EQUESTRIAN ESTATES

An Addition to Wichita - Sedgwick County, Kansas

RE: SUB 2001-48 -- Final Plat of Equestrian Estates Addition

STAFF REPORT

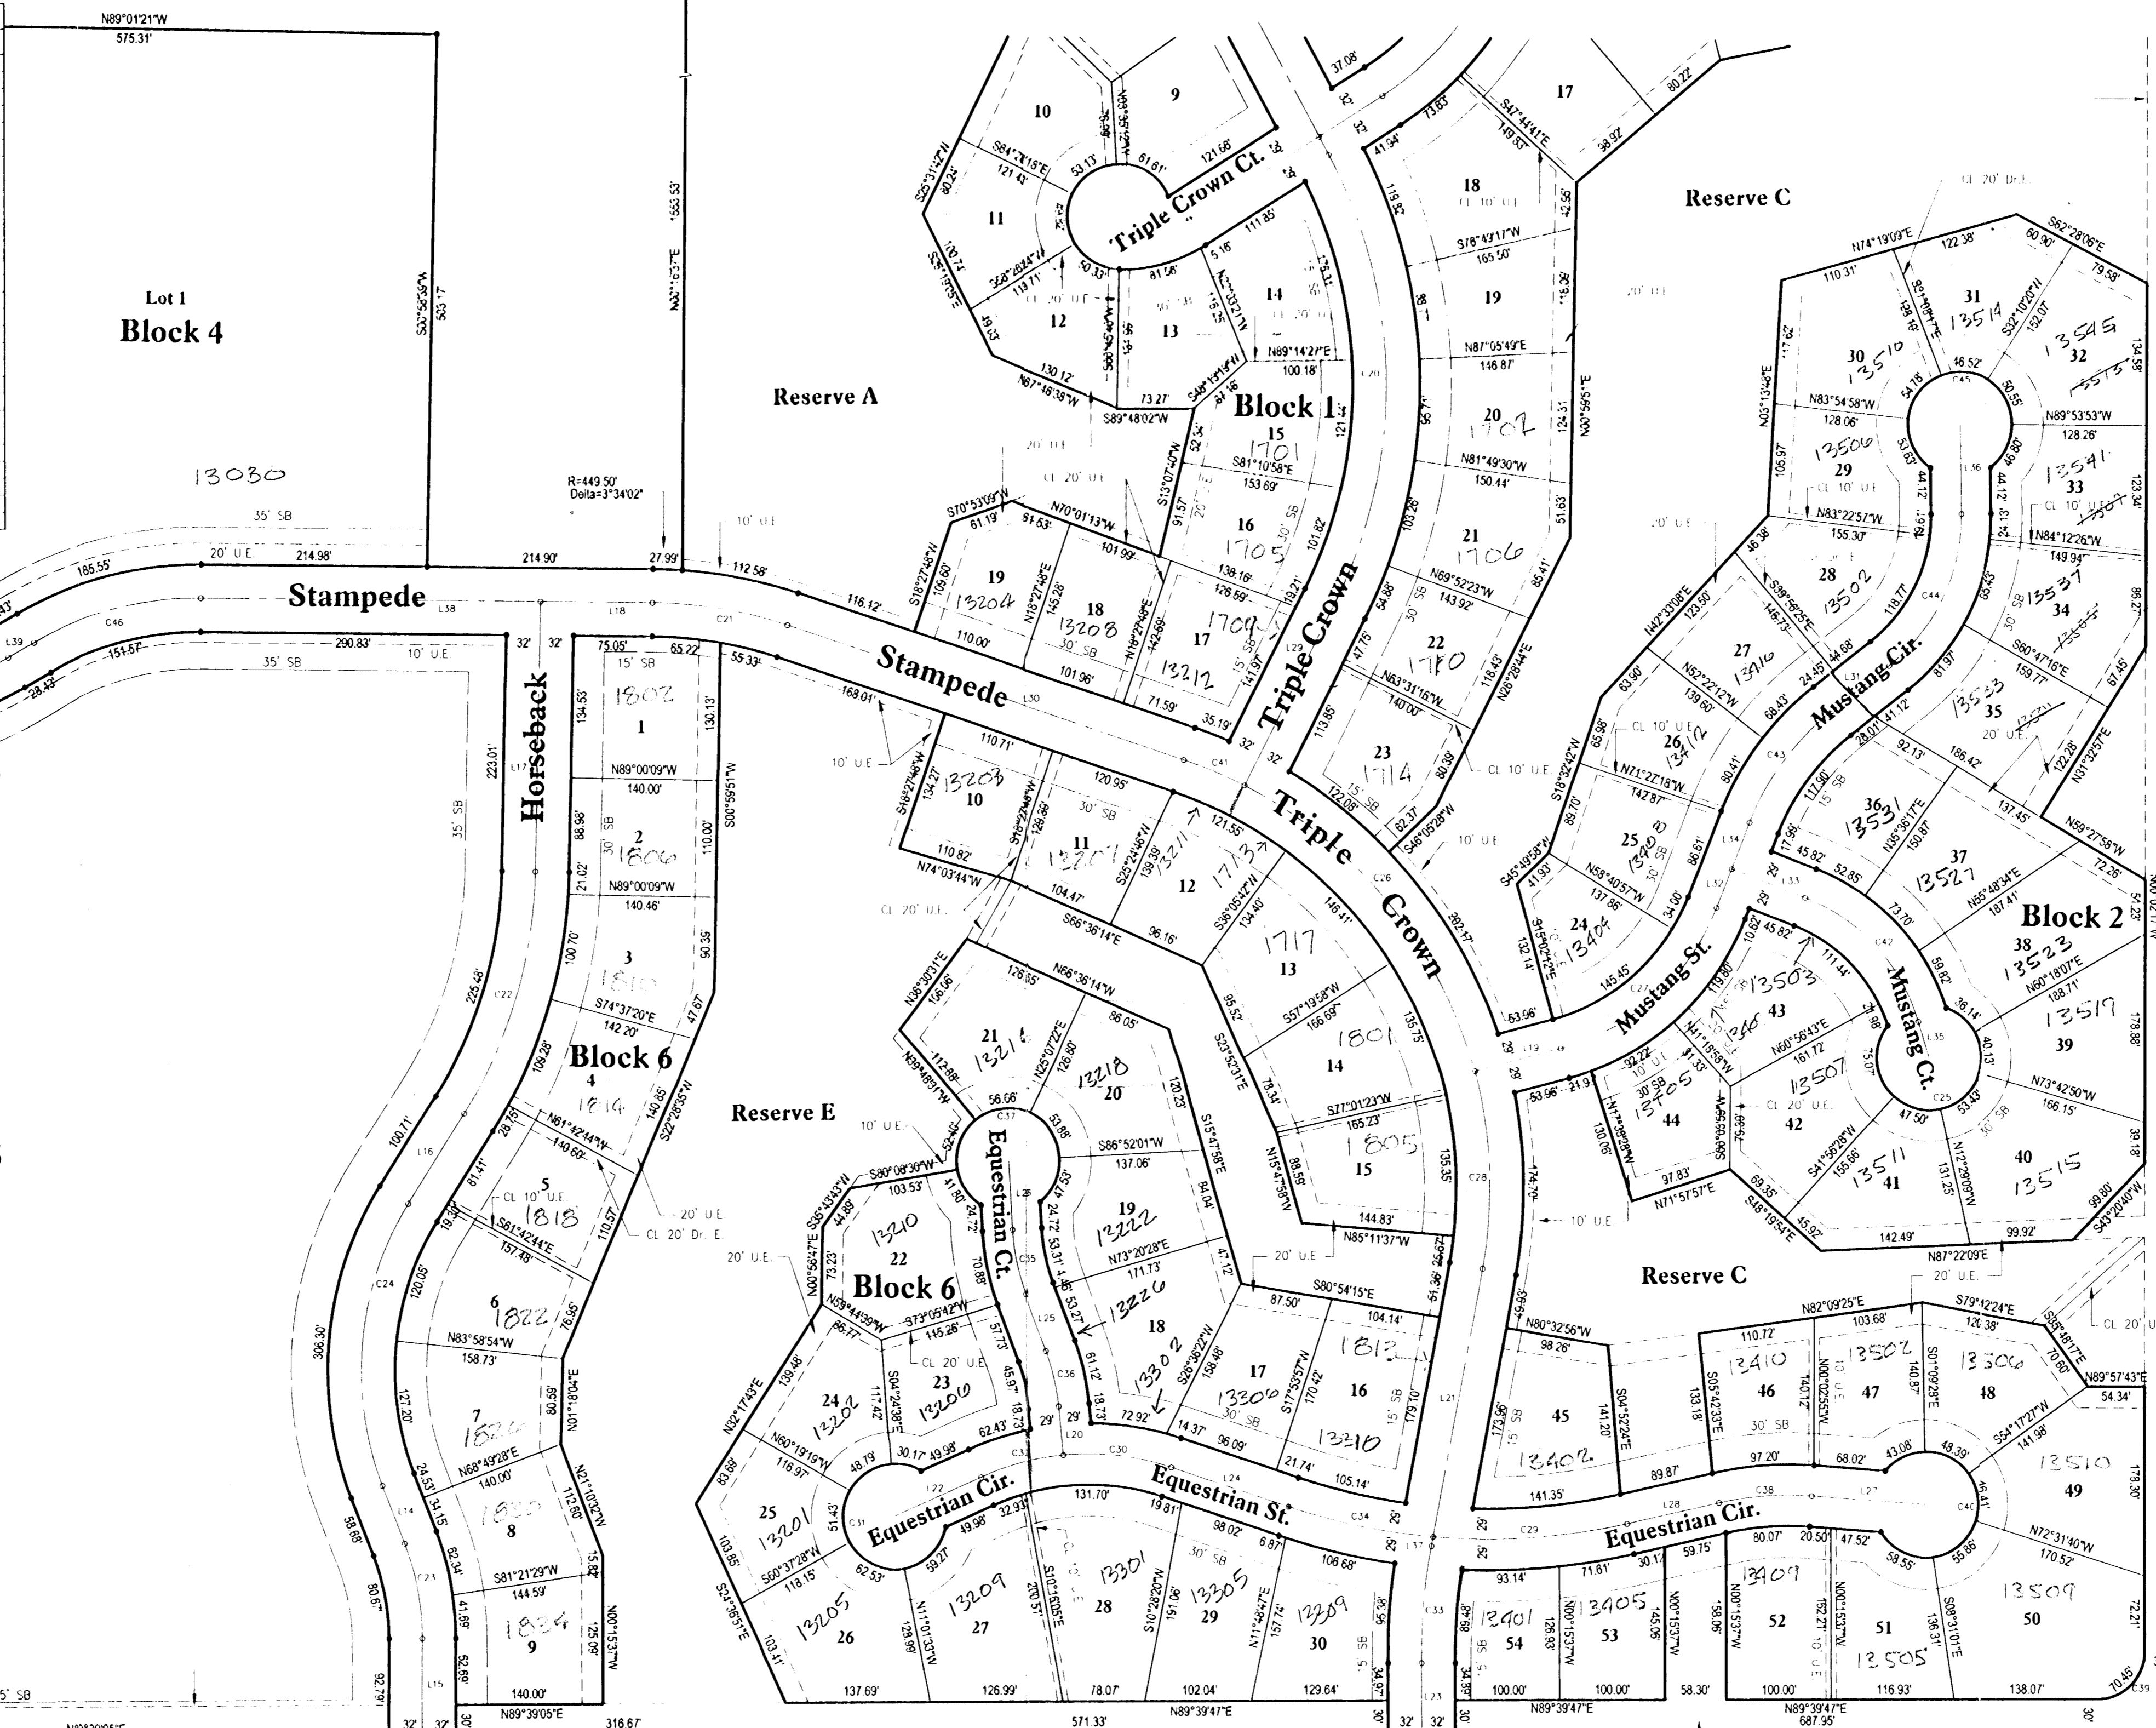
- A. As this site is adjacent to Wichita's City limits, the Applicant shall submit a request for annexation. Upon annexation, the property will be zoned SF-5, Single-Family Residential and allow for the lot sizes being platted. The final plat shall not be scheduled for City Council review until annexation has occurred.

- B. The applicant shall guarantee the extension of sanitary sewer to serve the lots being platted. This guarantee shall be with the City for service through the Four Mile Creek sanitary sewer system. An off-site sewer easement will be needed.

- E. City Engineering needs to comment on the status of the applicant's drainage plan. *The drainage plan is approved. Minimum pad elevations need to be shown for lots adjoining drainage ways.*

- F. The Applicant shall guarantee the paving of the proposed streets. The guarantee shall also provide for sidewalks on one side of the 64-ft loop and through streets.

- G. The paving guarantee shall include the installation of a temporary turnaround at the terminus of Horseback at the plat's south line. The temporary turnaround shall be established by separate instrument.

- H. County Engineering needs to comment on the need for street improvements. County Engineering has requested paving improvements to 127th Street East, including a left turn lane. A right-turn and left-turn bay on Harry is also requested.

- I. The applicant shall submit a covenant which provides for four (4) off-street parking spaces per dwelling unit on each lot which abuts a 58-foot street. The covenant shall inventory the affected lots by lot and block number and shall state that the covenant runs with the land and is binding on future owners and assigns.

- L. Reserves B and G need dimensioned and located.
- M. If any of the intended recreational uses for the reserves includes a swimming pool, a site plan shall be submitted with the final plat, for review and approval by the Planning Director. The site plan shall include the information indicated in the Subdivision Regulations. Otherwise a conditional use and public hearing will be needed in the future.

- O. The connection of Stampede Street with 127th St. East is not in accordance with Parcel No. 3 of the PUD site plan; and an adjustment is needed.
- P. PUD General Condition 5b requires that roads within Parcel No. 3 will be privately owned and maintained. The PUD needs to be adjusted to eliminate this condition.

- Q. The Fire Department needs to comment on the plat's street names. Revised street names are required.

The street names have been revised as requested.
- R. City Fire Department needs to comment on the street length of Mustang Court (780 feet) in Block 2. The Subdivision Regulations limit cul-de-sacs to 600 feet in length. The length of the street is approved.
- S. The Applicant is reminded that a platting binder is required with the final plat. Approval of this plat will be subject to submittal of this binder and any relevant conditions found by such a review.

The utility easements between Lots 27 and 28, Block 6; Lots 14 and 15, Block 6; and between Lots 25 and 26, Block 2 need to be labeled.
- CC. The applicant is reminded that a disk shall be submitted with the final plat tracing to the Planning Department detailing this plat in digital format in AutoCAD. This will be used by the City and County GIS Department.
